**TOWN OF NEWBURGH  
PLANNING BOARD  
TECHNICAL REVIEW COMMENTS**

**PROJECT: HADID CLEARING & GRADING APPLICATION-34 SUSAN DR.**  
**PROJECT NO.: 21-10**  
**PROJECT LOCATION: SECTION 46, BLOCK 5, LOT 21**  
**REVIEW DATE: 28 MAY 2021**  
**MEETING DATE: 3 JUNE 2021**  
**PROJECT REPRESENTATIVE: ENGINEERING & SURVEYING PROPERTIES**

**RE: W.O. # 1592.01  
PB APPLICATION 2021-10  
HADID  
34 SUSAN DRIVE  
COMMENT RESPONSE**

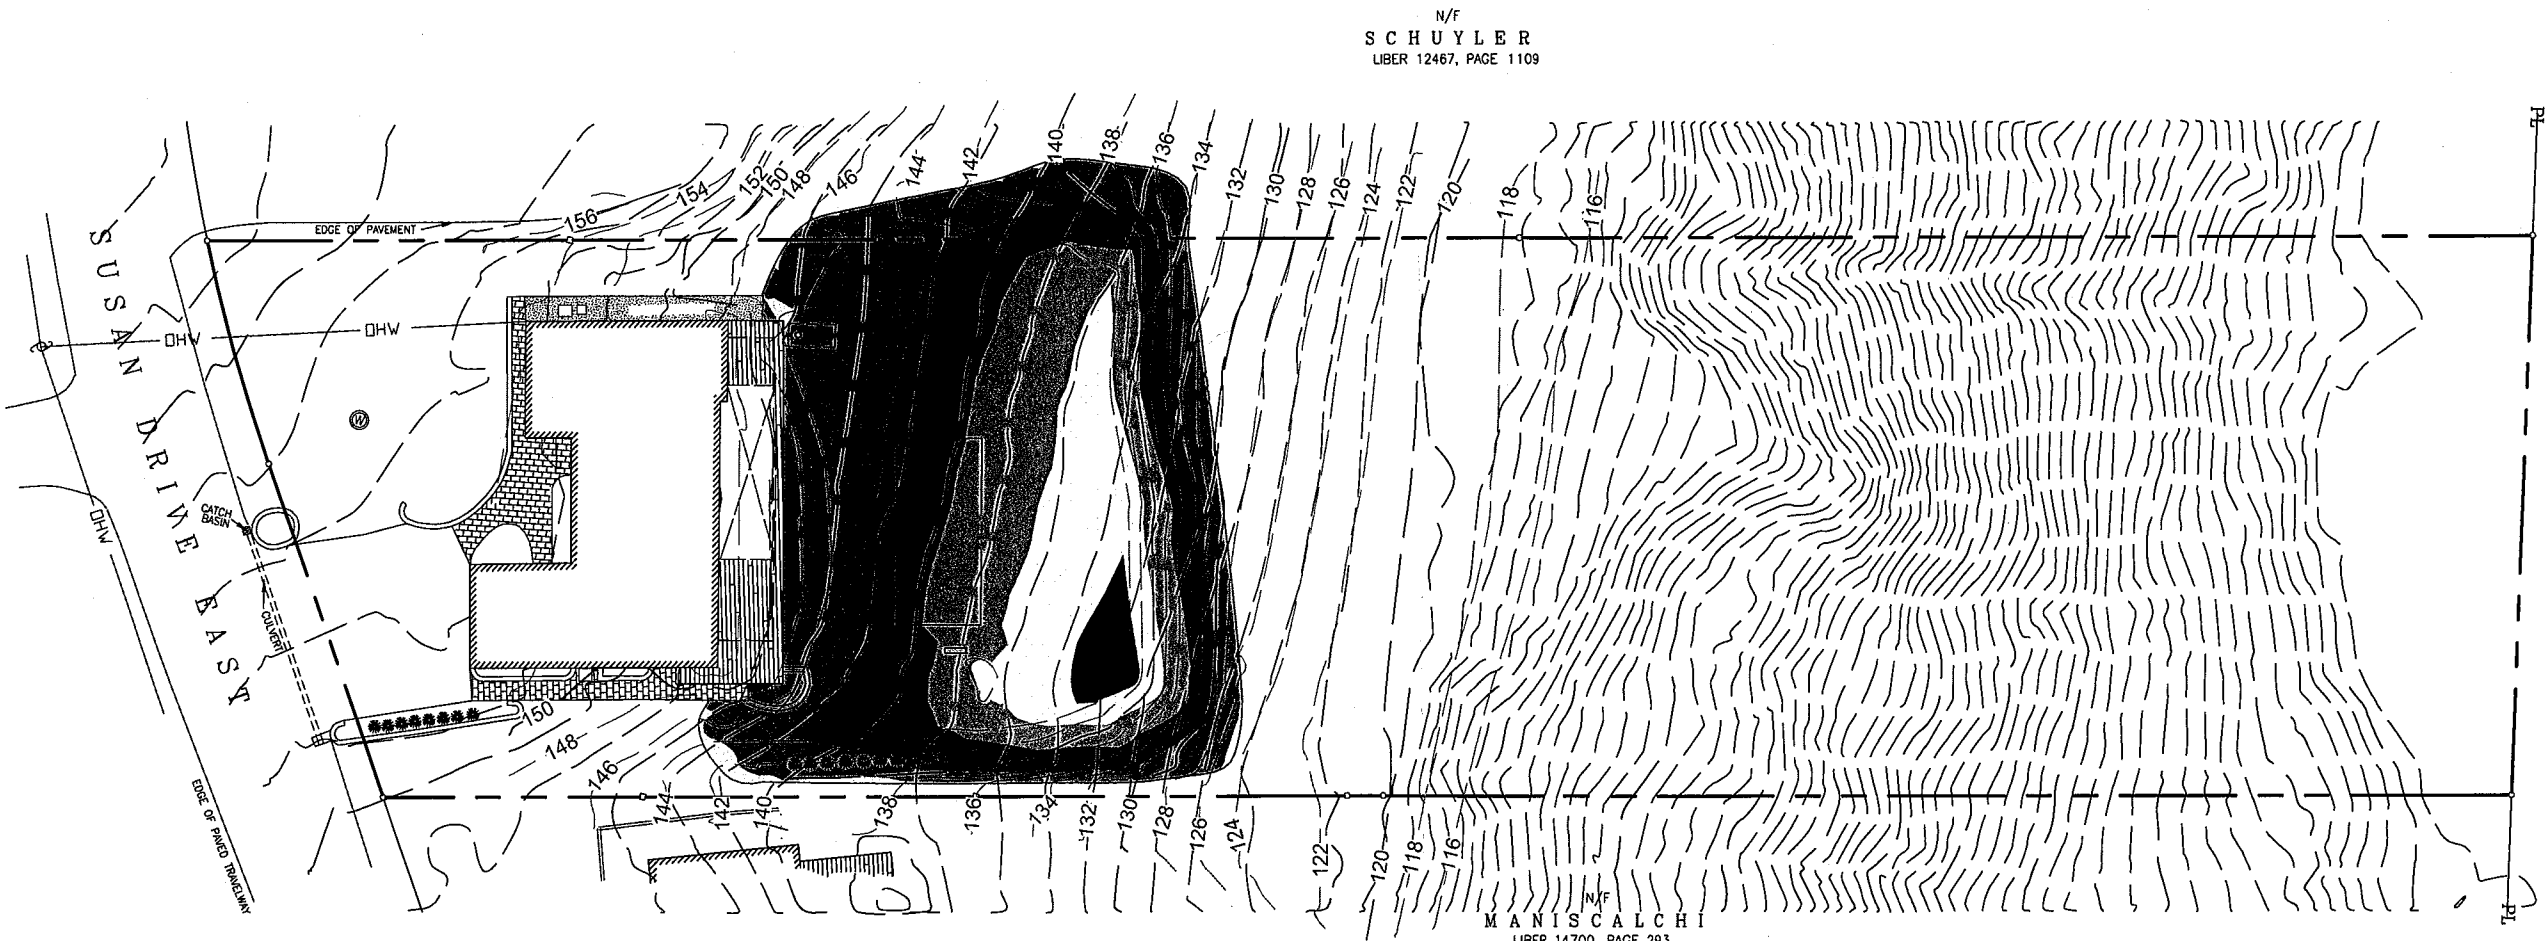
2. The Applicants representative has provided a clearing and grading permit dated 5 January 2021 identifying 1,500 cubic yards of fill to be placed on the site. In the recent submission the Applicant representative has submitted a schematic computer model identifying 2,345 cubic yards of fill on the site. It is noted the computer model uses a 3 foot contour interval to evaluate the amount of material placed.

9. A cut / fill figure (Sheet F-1) has been prepared which compares the contour data provided by Steven P. Drabick P.L.S. (which has been raised 2 feet to approximate the North American Vertical datum of 1988) and USGS 1M hydro-flattened digital elevation models (DEMS) as derived from 2012 source lidar. The volume of fill placed on site is approximately 2,345 cubic yards.
